# UNITED STATES PATENT AND TRADEMARK OFFICE

10/563,993

<b>Office Action Summary</b>	<b>Application No.</b> 10/563,993	<b>Applicant(s)</b> REICHENBACH ET AL.	
	<b>Examiner</b> PUNAM PATEL	<b>Art Unit</b> 2855

## **DETAILED ACTION**

Annotated Fig. 8 below; Abstract; & ¶s 43, 51-54.

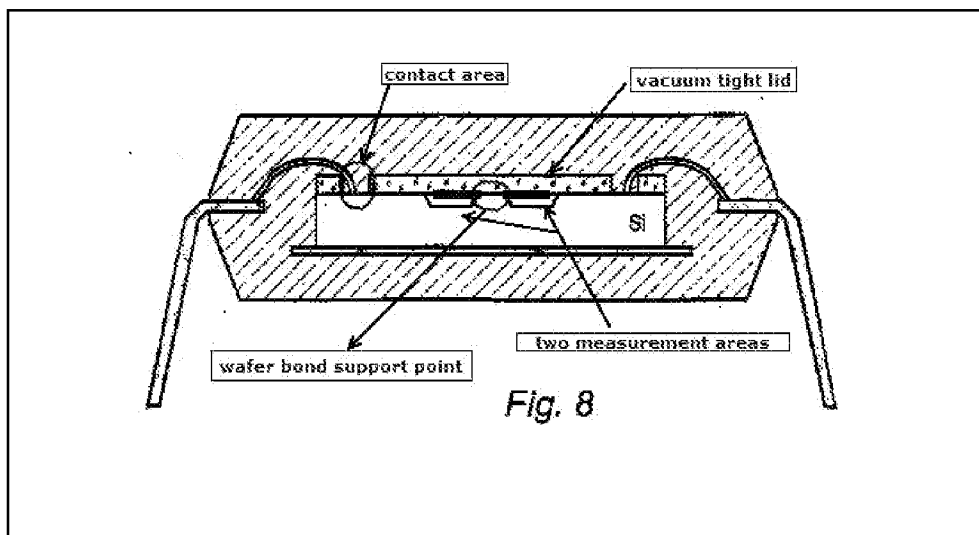
With respect to Claims 19 and 31, Landsberger discloses an apparatus comprising:  
a measurement chip (the Si substrate) with a first and second measurement area/structure formed thereon (the cantilever structures);  
the measurement areas being offset in a lateral direction;  
a cap chip fastened to the measurement chip in a connecting area and at a point between the two measurement areas (read as wafer bond support point);  
intermediate space (the cavity) between the cap chip and the measurement chip; and  
at least

one contact area not covered by the cap chip. See

With respect to Claim 21, 25, and 27, Landsberger further discloses two contact areas formed on opposing sides of the measurement chip and left exposed by the cap chip. See Annotated Fig. 8 below.

With respect to Claim 35, Landsberger further discloses a lead frame, a housing, and wire bonds. See Annotated Fig. 8 above. (Compare to Applicant's Fig. 8).
